RE: **Lot 15 Block 2 Unit 5 Unser Cliffs SAD 227**
6912 Rimrock NW
Grading and Drainage Plan
Engineers Stamp Date 7/18/17 (D10D009)

RE: **Lot 15 Block 2 Unser Cliffs SAD 227**
6912 Rimrock NW
Grading and Drainage Plan
Engineers Stamp Date 7/16/17 (D10D009)

ENGINEER'S SEAL  7/18/17 7/16/17 DAVID SOULE P.E. #14522	6912 RIM ROCK	DRAWN BY WCWJ
	GRADING AND DRAINAGE PLAN	DATE 7-15-17
	 Rio Grande Engineering 1606 CENTRAL AVENUE SE SUITE 201 ALBUQUERQUE, NM 87106 (505) 872-0898	21764-LAYOUT-7-14-17
		SHEET # — JOB # 21764

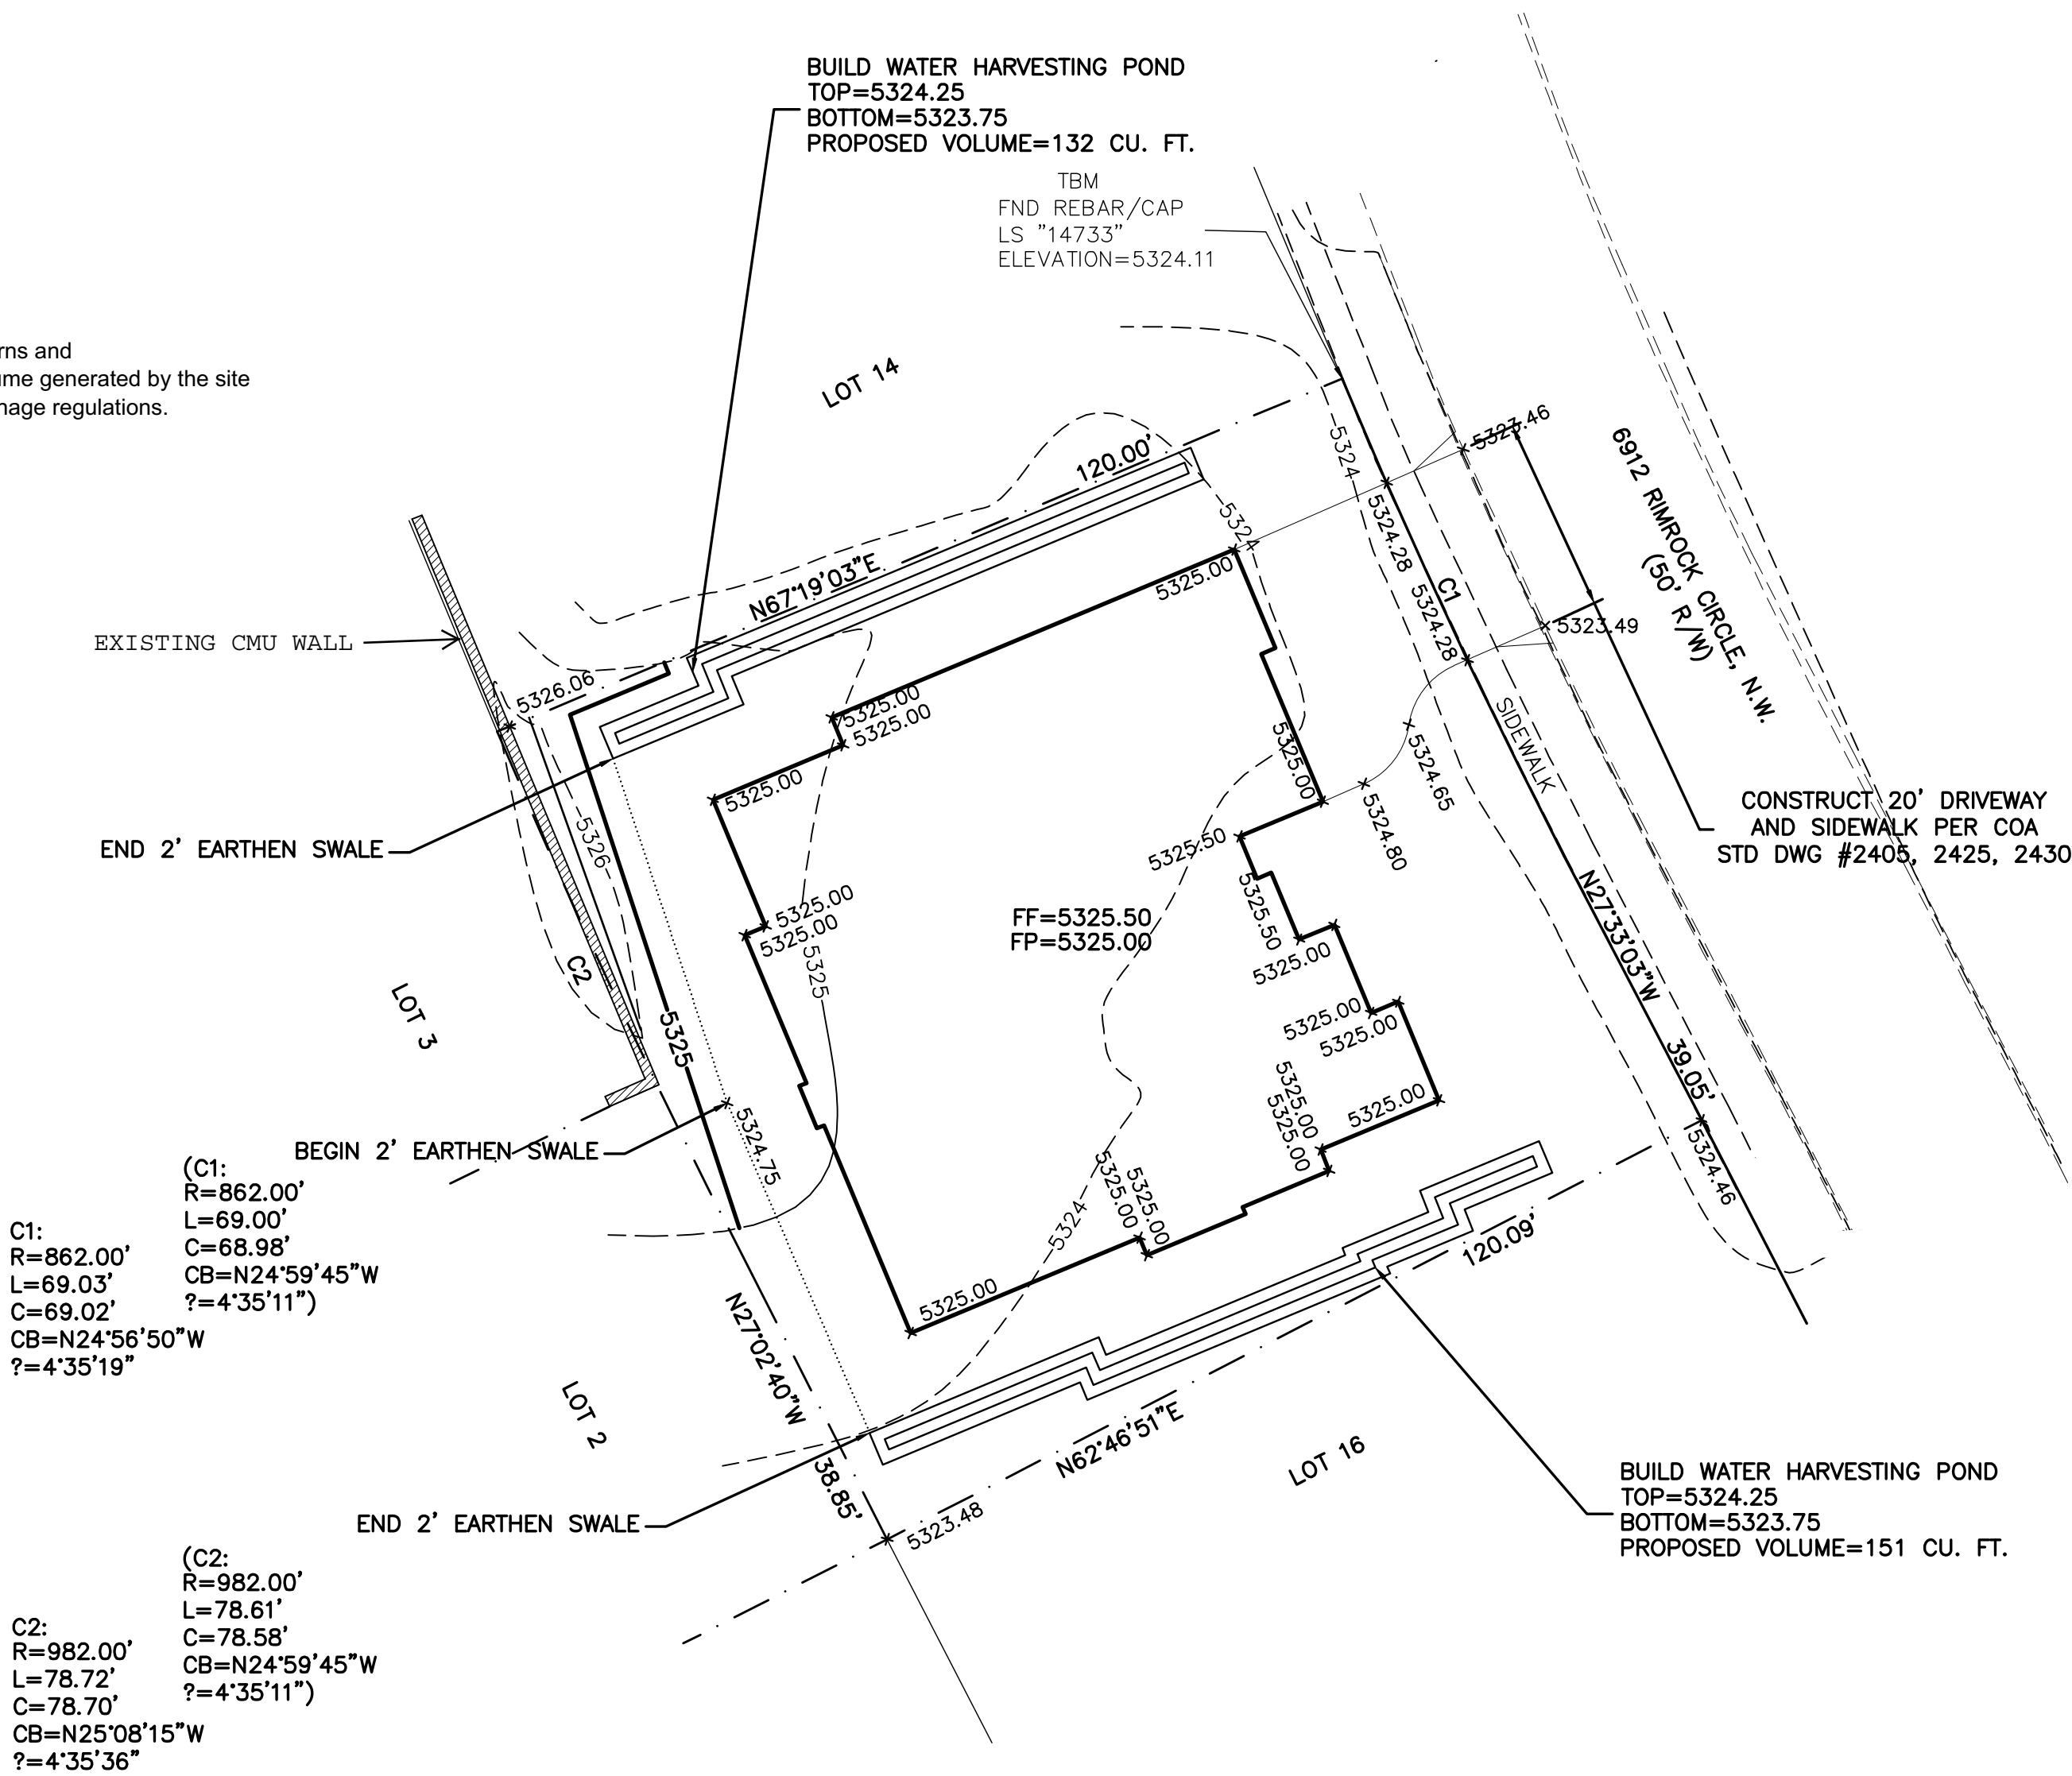
Based upon the information provided in your submittal received 7/17/17, this plan cannot be approved for Grading Permit until the following comments are addressed.

- Provide a statement on the plan stating that this grading plan must be used for the application of any garden/retaining walls. **added language to note #3**
- Provide a statement that a Pad Certification is required before building permit can be approved. **note#4 shows this**

- ALL SPOT ELEVATIONS REPRESENT FLOWLINE ELEVATION UNLESS OTHERWISE NOTED.
- ALL SLOPES SHALL BE 3:1 MAX. AND GRAVEL OR NATIVE SEEDING PRIOR TO CO.
- ANY PERIMETER WALLS MUST BE PERMITTED SEPARATELY. ALL RETAINING WALL DESIGN SHALL BE BY OTHERS. THIS PLAN MUST BE SUBMITTED WHEN PERMITTING ANY WALLS.
- A PAD CERTIFICATION IS REQUIRED PRIOR TO RELEASE OF BUILDING PERMIT
